# Section 42A Officer's Report

## Errata

<b>Hearing Stream 2:</b>	Business
<b>Subjects:</b>	<b>Commercial and Mixed Use Zones</b> (this report) Contaminated Land and Hazardous Substances <b>Industrial Zones and the Seaview Marina Zone</b> (this report)
<b>Prepared by:</b>	Stephen Davis Senior Policy Planner, Hutt City Council
<b>Reviewed by:</b>	Nathan Geard Policy Planning Manager, Hutt City Council
<b>Report Date:</b>	7 May 2026
<b>Date of Hearing:</b>	25-29 May 2026

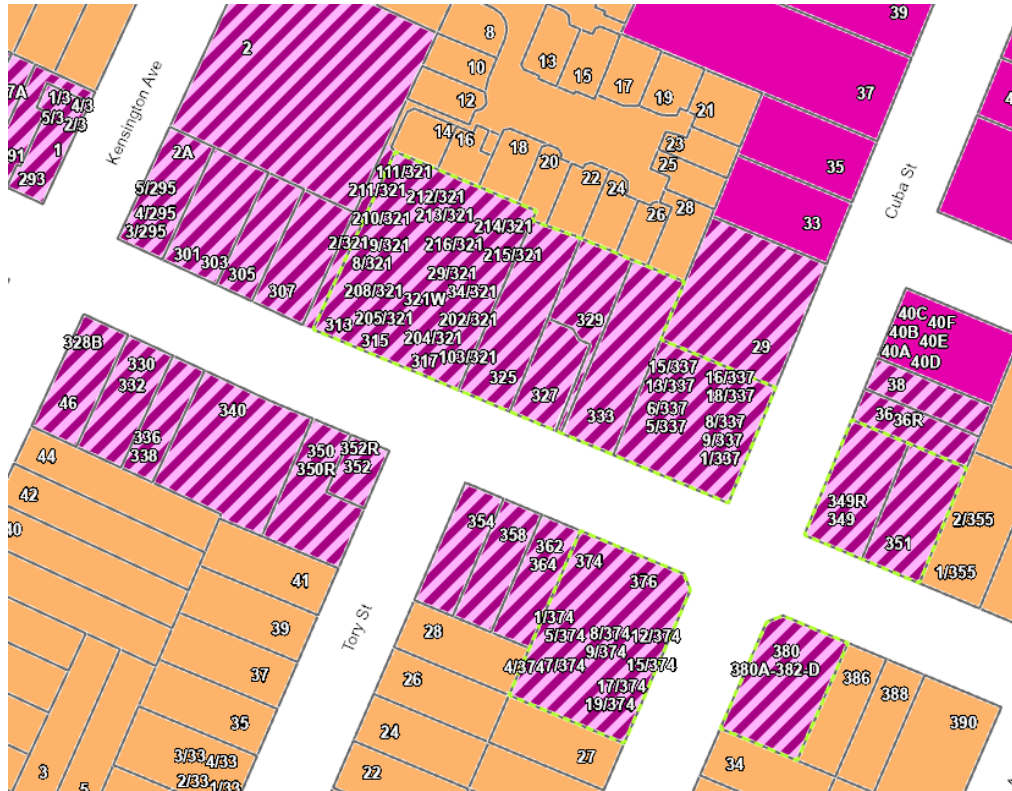
- (10) The Policy Planning Team (440.94) seeks that the Civic Precinct boundary be re-aligned to match the City Centre Zone boundary at the south-western edge. The discrepancy is shown below:

- (11) This would correct an error introduced between the draft and the notified plan where the City Centre Zone boundary was redrawn to better match the designation boundaries, but the precinct was not updated.
- (12) The precinct is proposed as a single-zone precinct and would have no effect in the Open Space Zone, and so removing it would likewise have no effect.

- (13) As this is merely correcting a clear error and would have no substantive effect on the plan I recommend accepting this relief.
- (14) No Section 32AA analysis is needed as this would not be a substantive change.

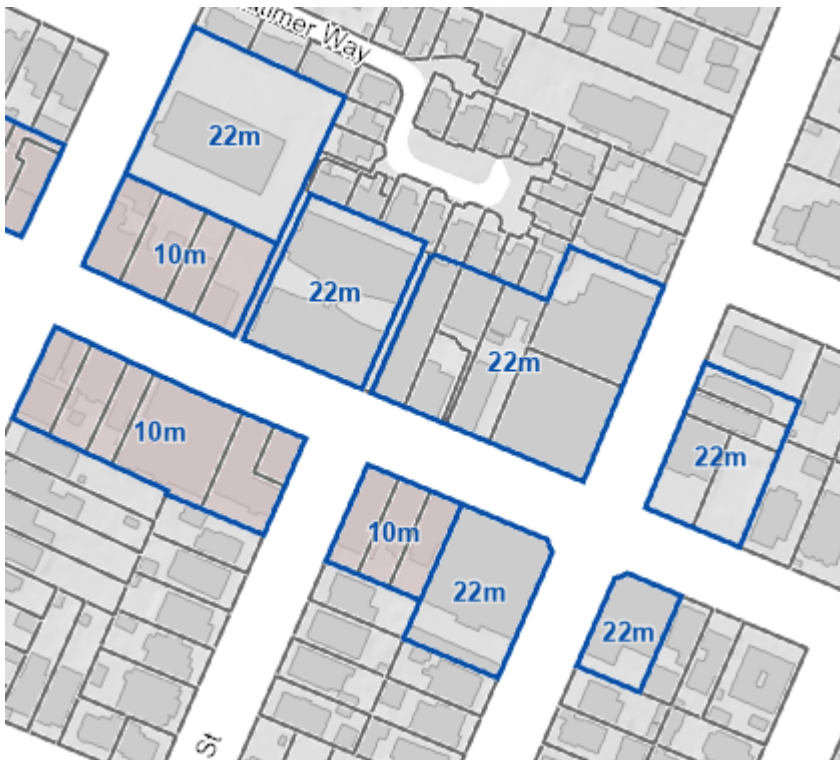
- (25) The Petone Historical Society (496.63b, 496.61) seeks to replace the 22 metre Specific Height Control Overlay with a 10-metre overlay at the eastern end of Jackson Street:

- (31) Accordingly, I do not recommend accepting this relief.
